CONTRACT CHANGE ORDER NO. ____
SHEET ____ OF ____

MARK	DATE	DESCRIPTIONS	BY	CH'D	CCO#
2	01/05/12	FIELD MODIFICATION OF SUSPENDER BRACKETS	GB	MN	230
1	12/31/09	SUSPENDER BRACKETS	GB	MN	104
0	02/20/09	SUSPENDER BRACKETS	GB	MN	104

SAN FRANCISCO OAKLAND BAY BRIDGE
EAST SPAN SEISMIC SAFETY PROJECT
SELF-ANCHORED SUSPENSION BRIDGE
(SUPERSTRUCTURE & TOWER)

SUSPENDER BRACKET DETAILS NO. 8

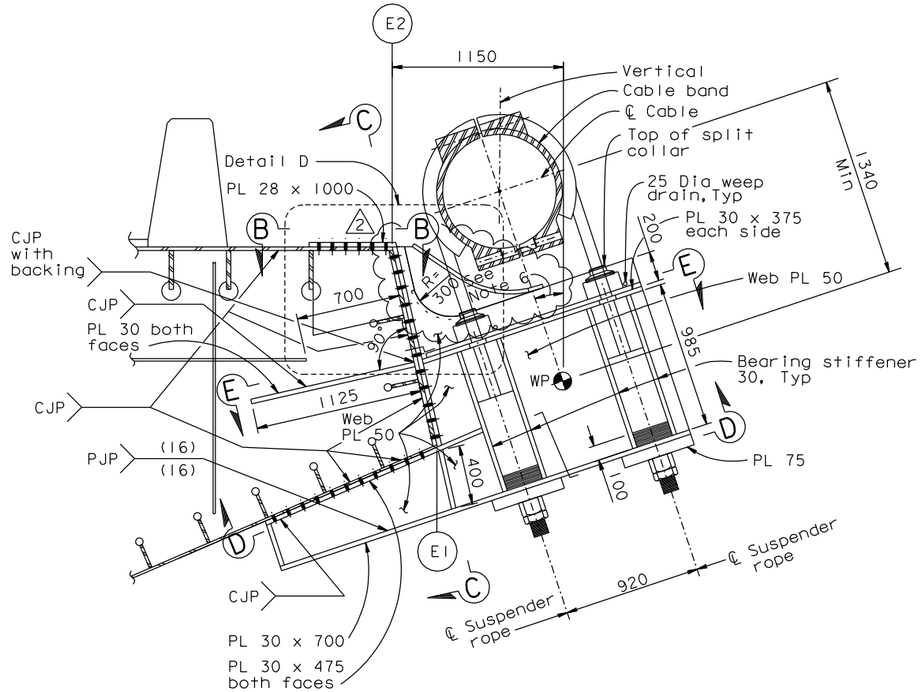
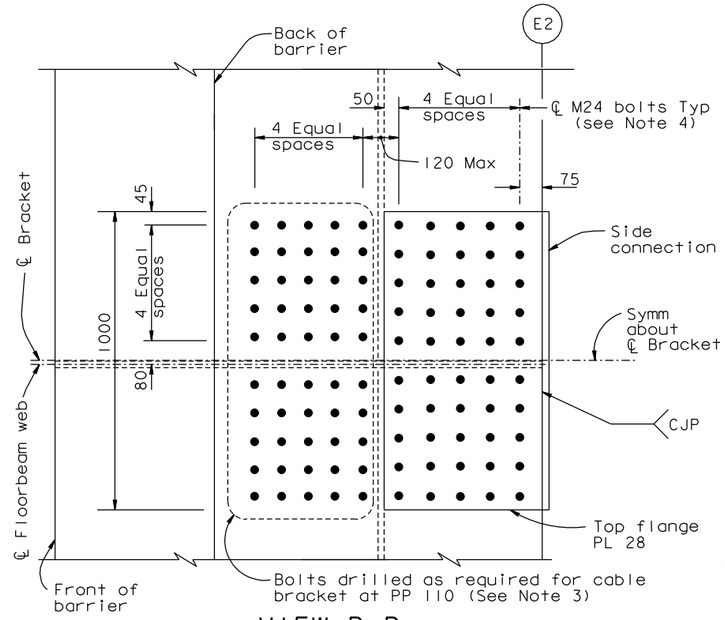
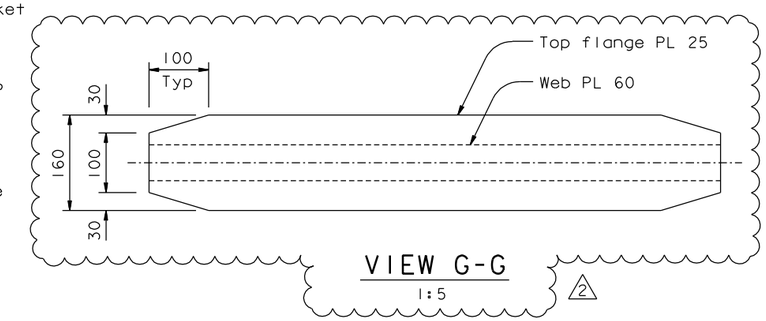
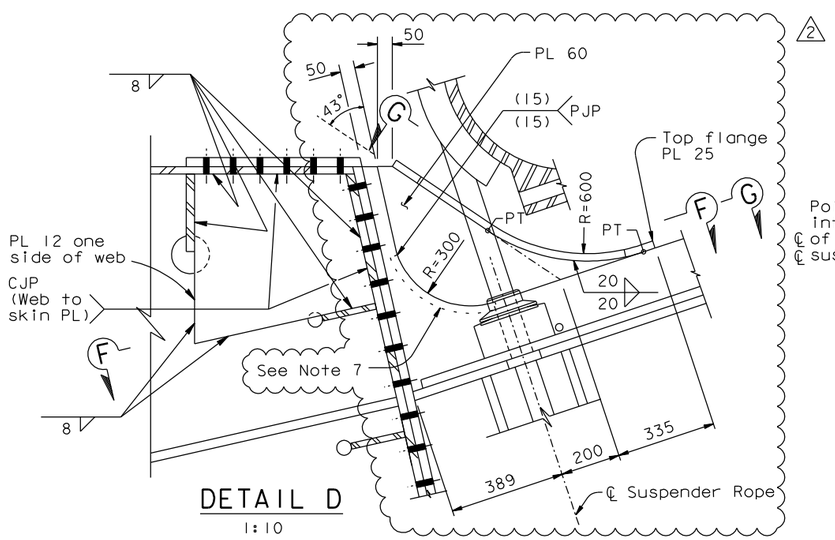
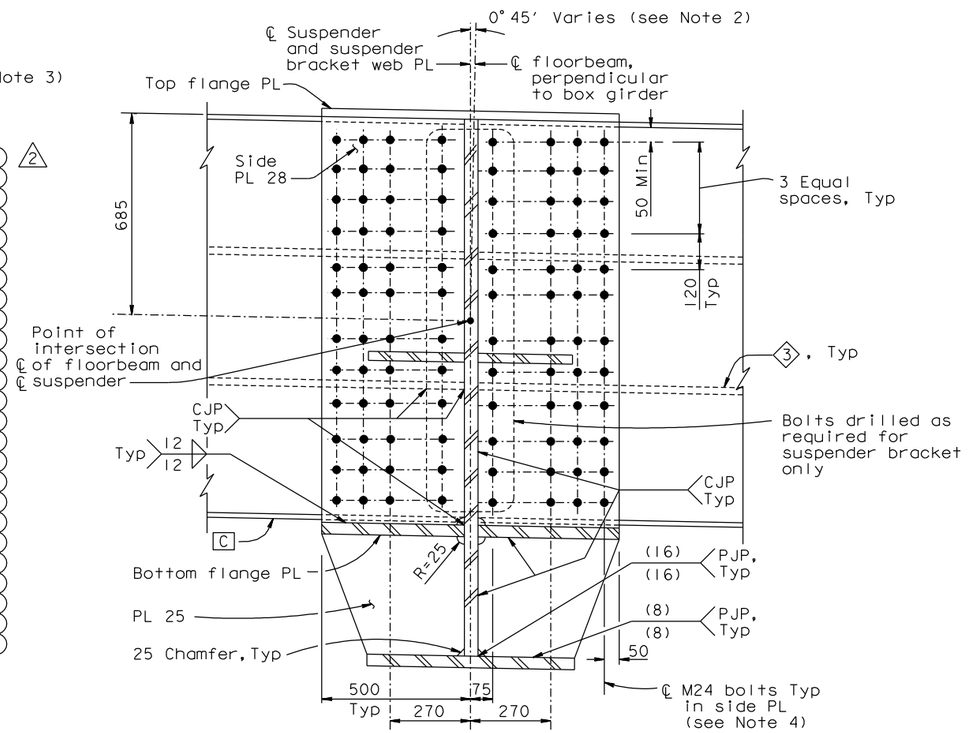
1. For details not shown, see "Suspender Bracket Details No.1" through "Suspender Bracket Details No.3" sheets.
2. The Contractor shall consider variation in roadway grade in his details.
3. The Contractor shall provide shop drawings for two cable brackets and for two suspender brackets at PP 110 ("E" line and "W" line). The Contractor shall fabricate and install either a cable bracket or a suspender bracket at PP 110 ("E" line and "W" line) as directed by the Engineer. For cable bracket details see "Cable Bracket Details" sheets.
4. Bolt spacings shall match cable bracket details, see "Cable Bracket Details" sheets.
5. For View D-D, Section E-E and F-F, see "Suspender Bracket Details No.9" sheet.
6. All suspender bracket components shall be fabricated to fit the computed cable profile.
7. Remove curve PL 20x50 from both sides and grind flush. (2)

SUSPENDER BRACKET DETAILS NO. 9

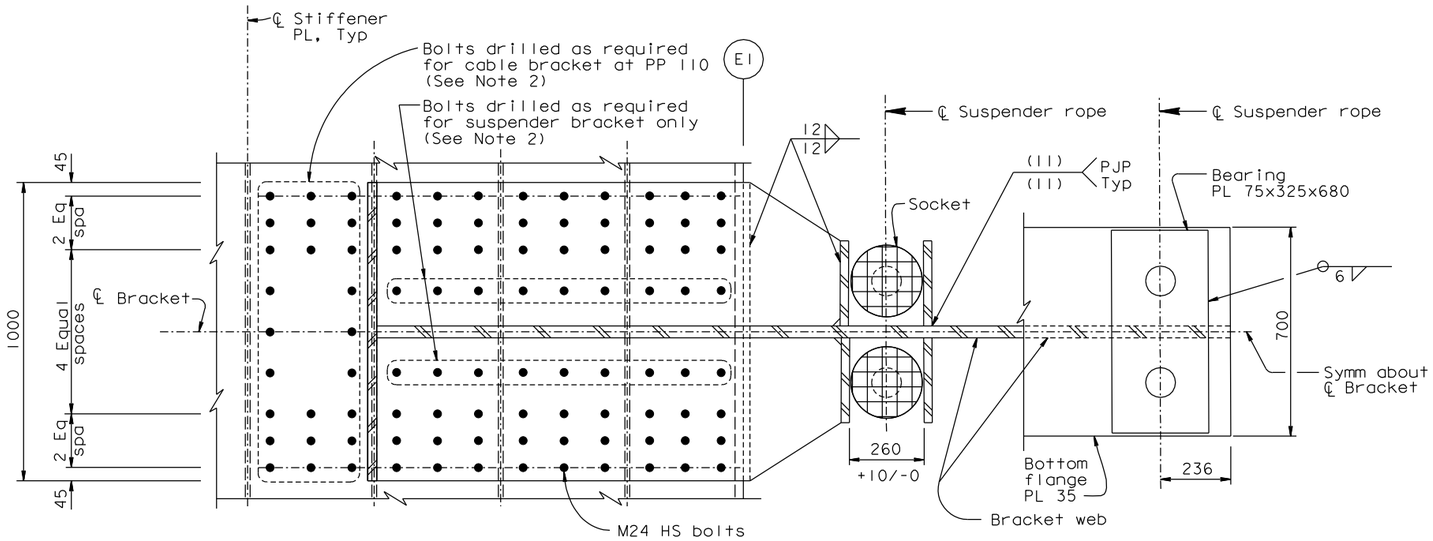
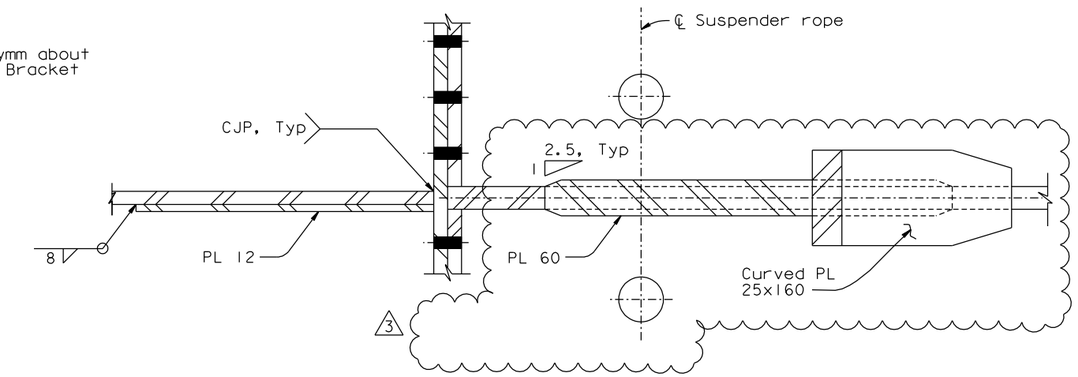
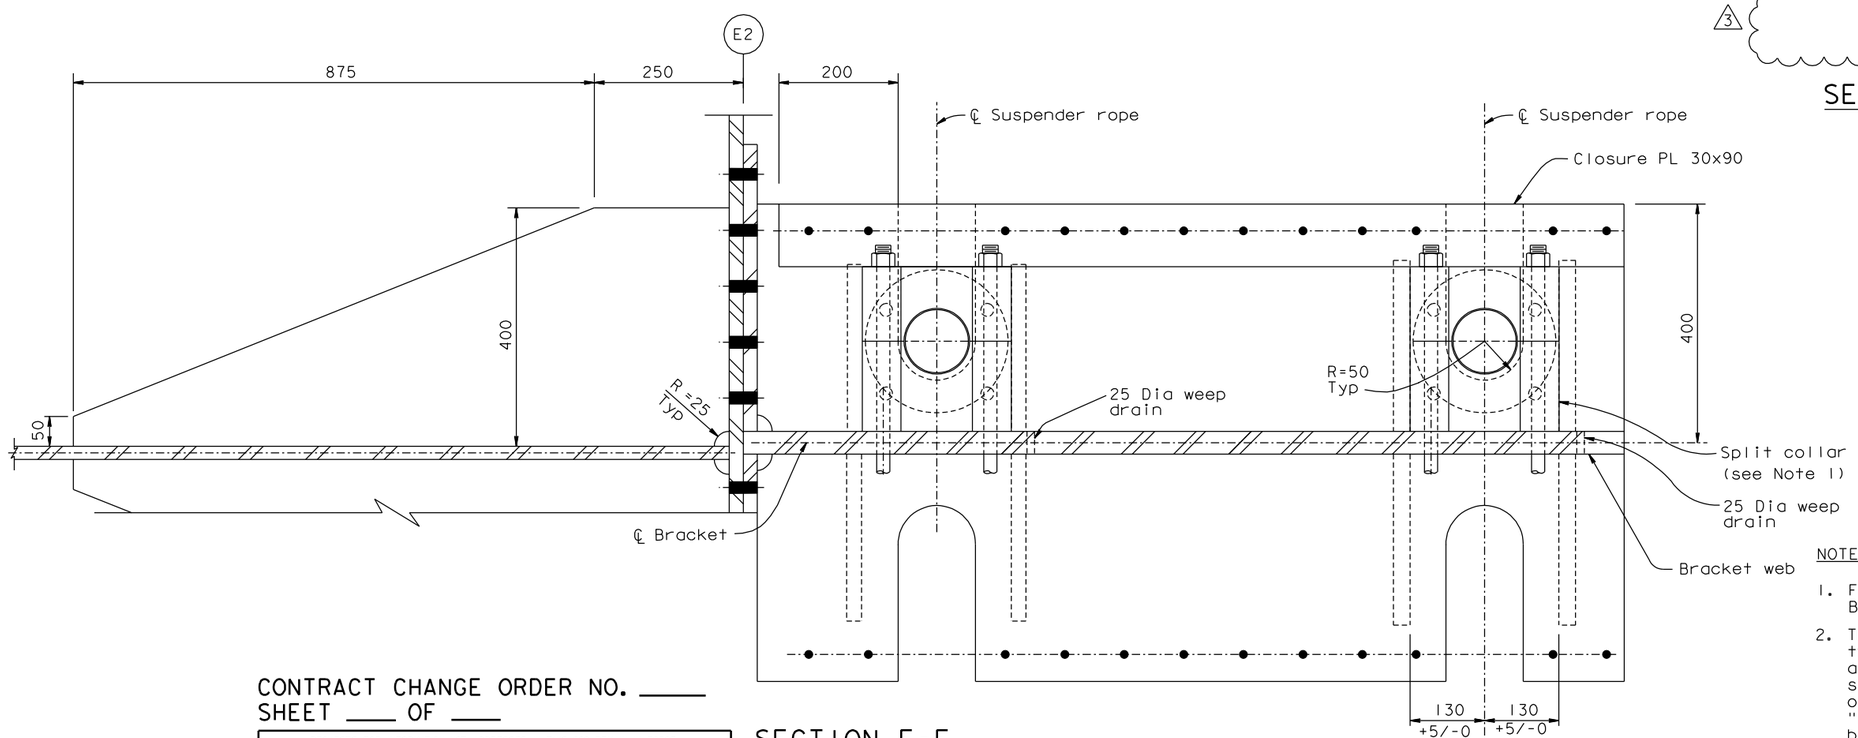
MARK	DATE	DESCRIPTIONS	BY	CH'D	CCO#
3	01/05/12	FIELD MODIFICATION OF SUSPENDER BRACKETS	GB	MN	230
2	06/11/10	SUSPENDER BRACKETS	GB	MN	104S1
1	12/28/09	SUSPENDER BRACKETS	GB	MN	104
0	02/20/09	SUSPENDER BRACKETS	GB	MN	104
